Docket No. 50-255

The Commission has issued the enclosed Amendment No. 37 to Provisional Operating License No. DPR-20 for the Palisades Plant. This amendment implements Technical Specifications for fire protection as proposed by our letter dated November 25, 1977, with modifications which reflect comments supplied in your letter of December 15, 1977.

AMENDMENT TO FACILITY OPERATING LICENSE

Amendment No. 37  
License No. DPR-20

FIGURE 6.2.2

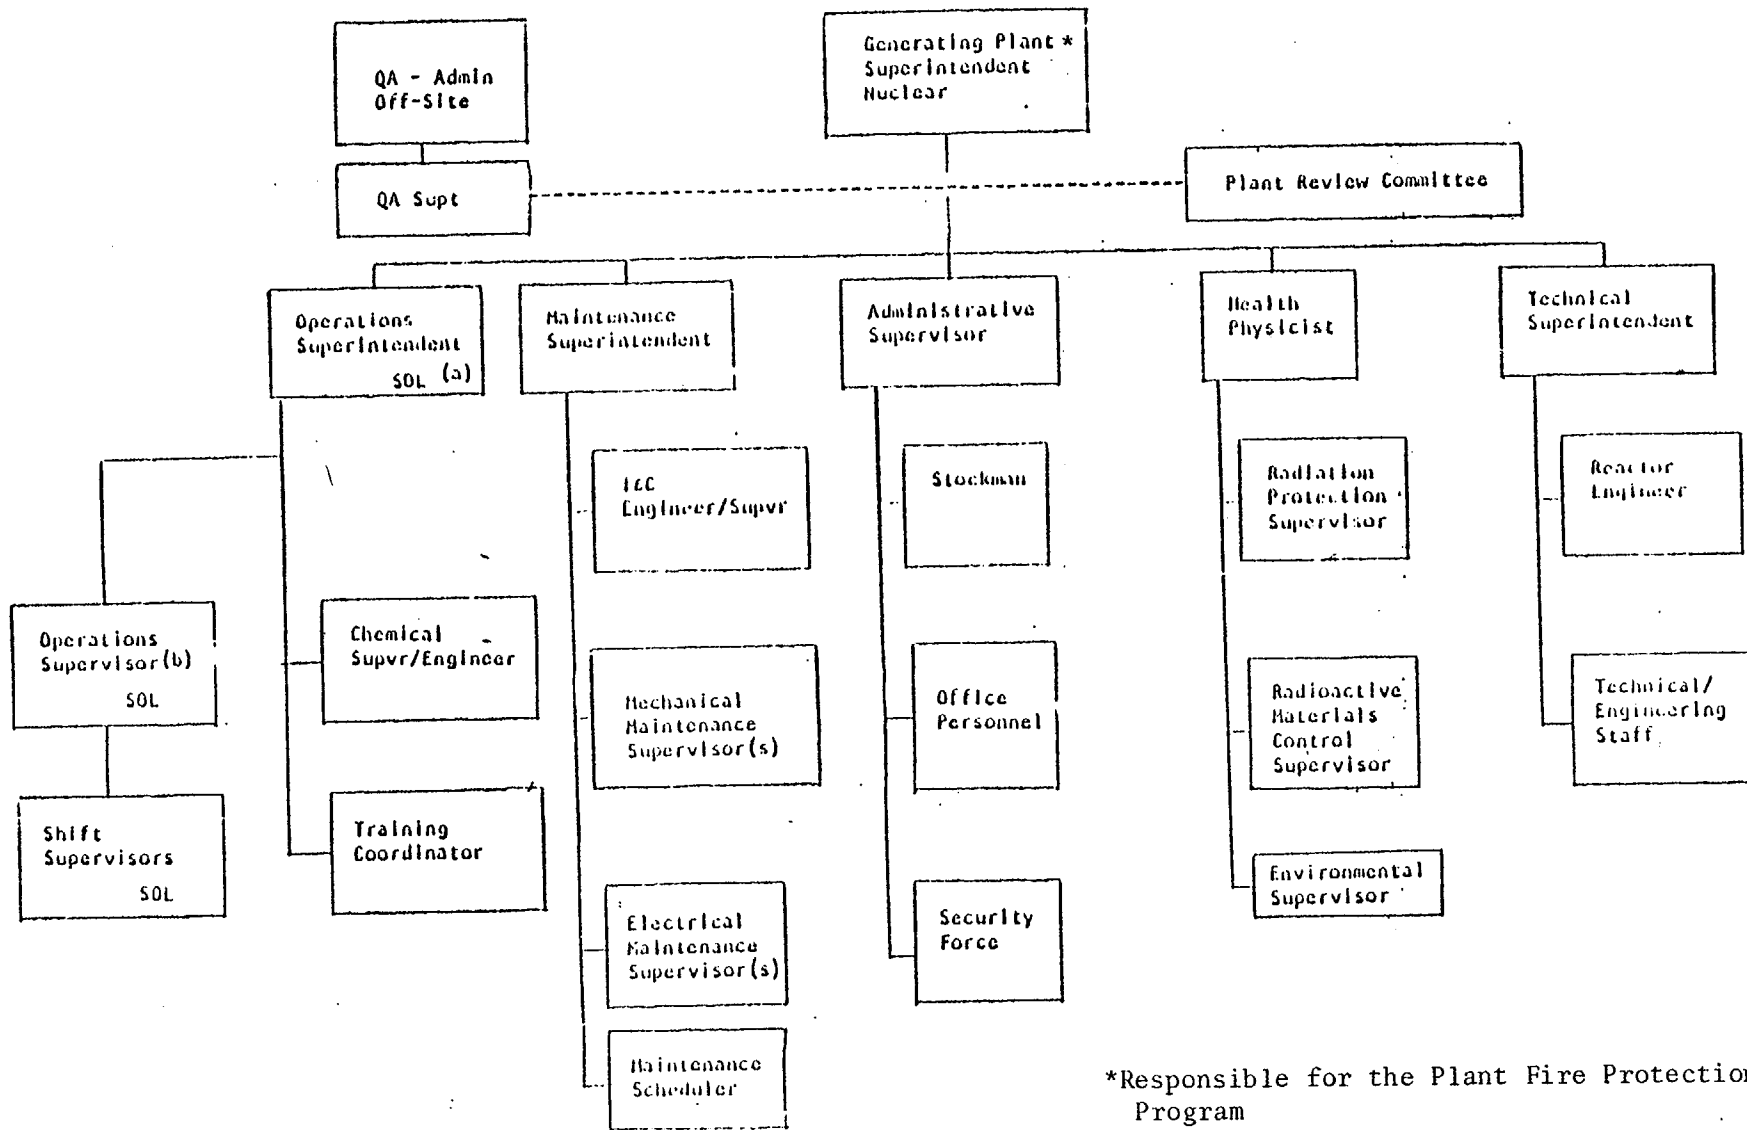
9. Section 4.17.2.2.b.1 has been modified to more clearly identify the tank from which the diesel fuel oil sample is to be taken.
10. Figure 6.2-2 has been modified to clearly restrict the superintendent's fire protection responsibilities to the Palisades Plant only.

\*Responsible for the Plant Fire Protection Program
